ADDENDUM # 2
QUOTE 22-66-1620

For: Removal and installation of new flooring at the Forsyth County North & South Precincts

South Precinct Photos

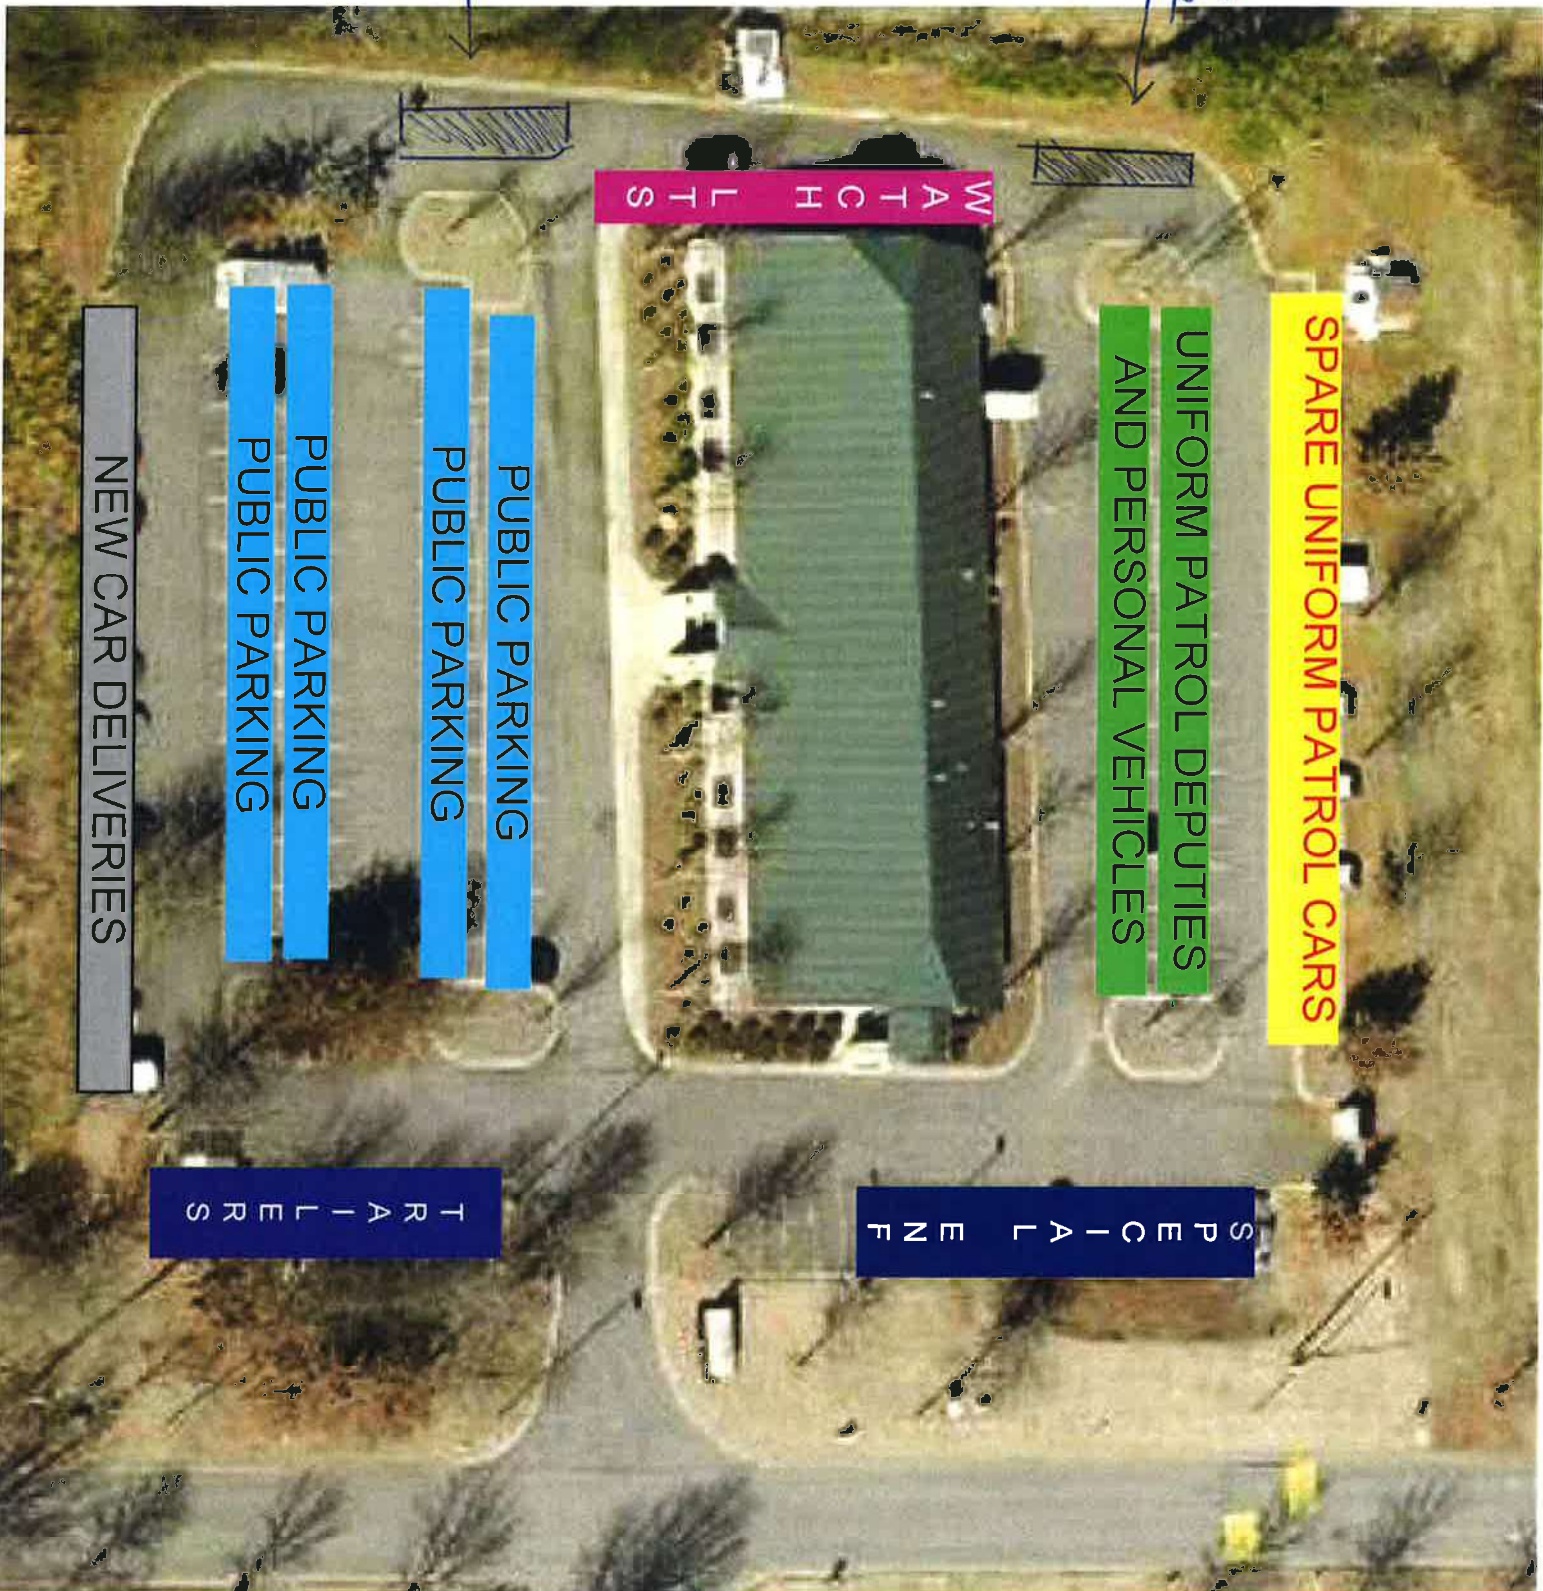
10. Can we please get a picture of the server room at the South Precinct?

Answer: Please see attached pictures.

South Precinct

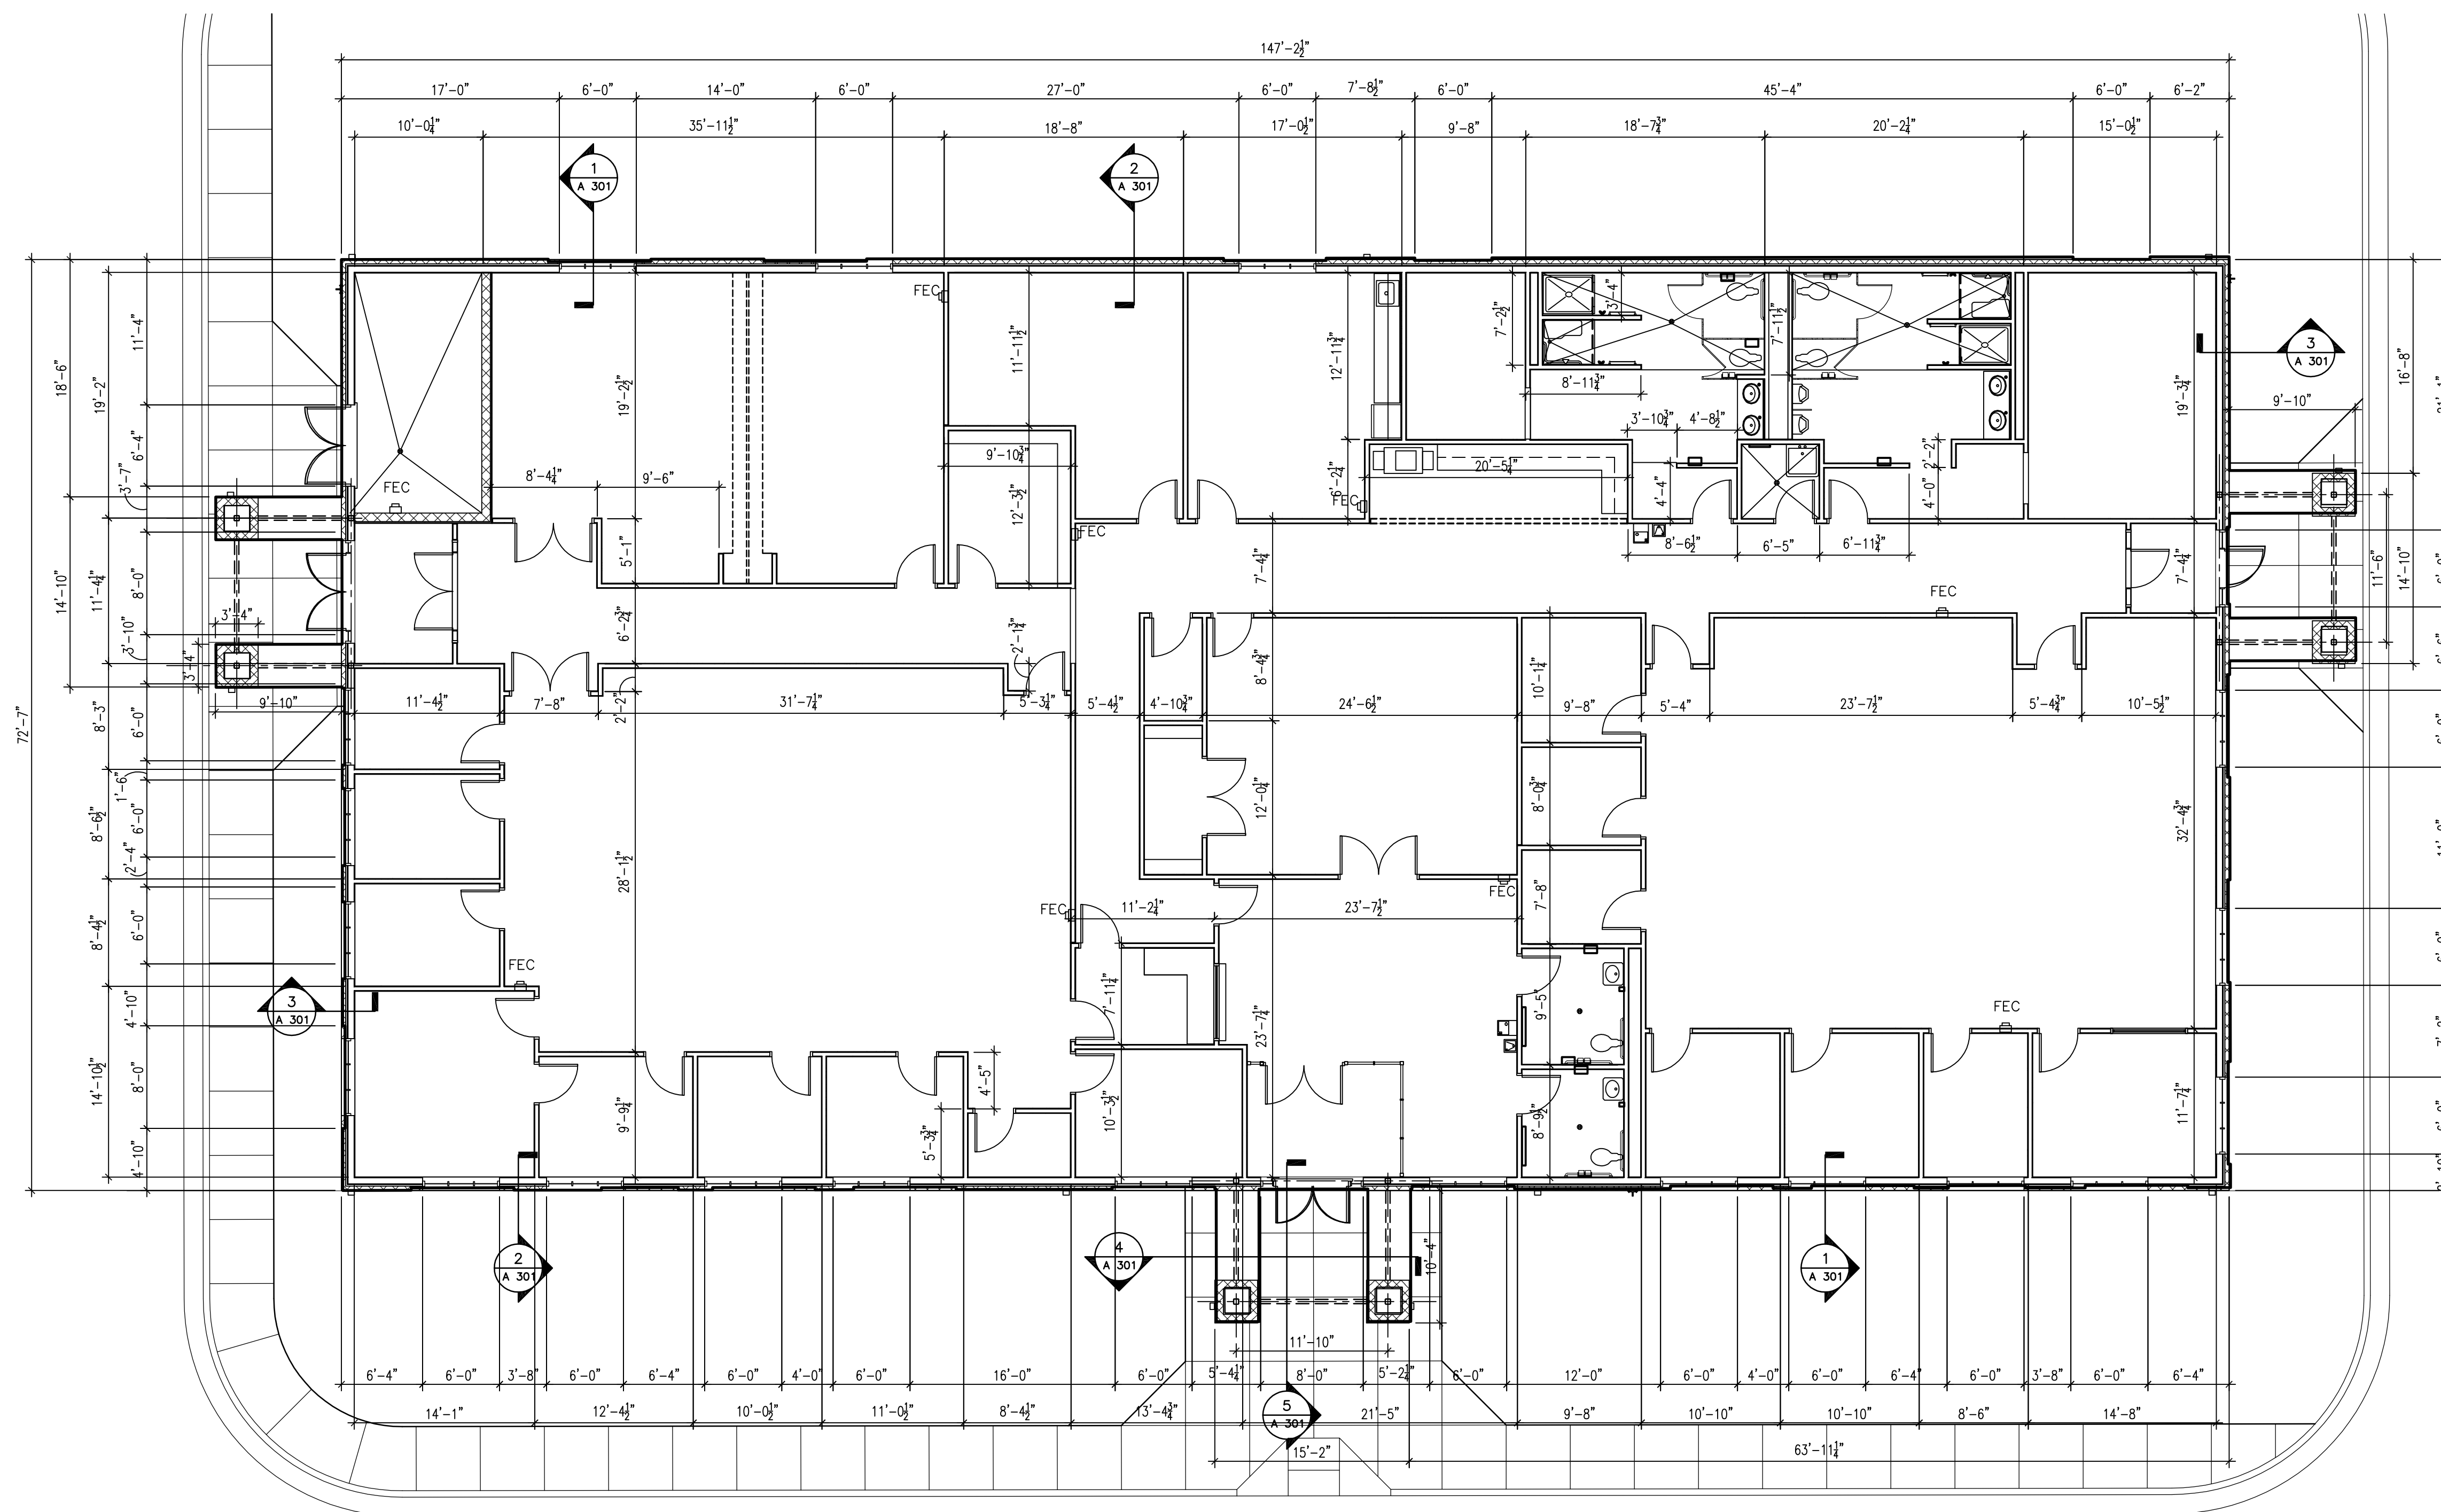
8. Where can we store the dumpster on site?

11. Can we please get a blueprint of North & South Precinct?

Answer: Yes

Answer: Yes, please see attached blueprints below.
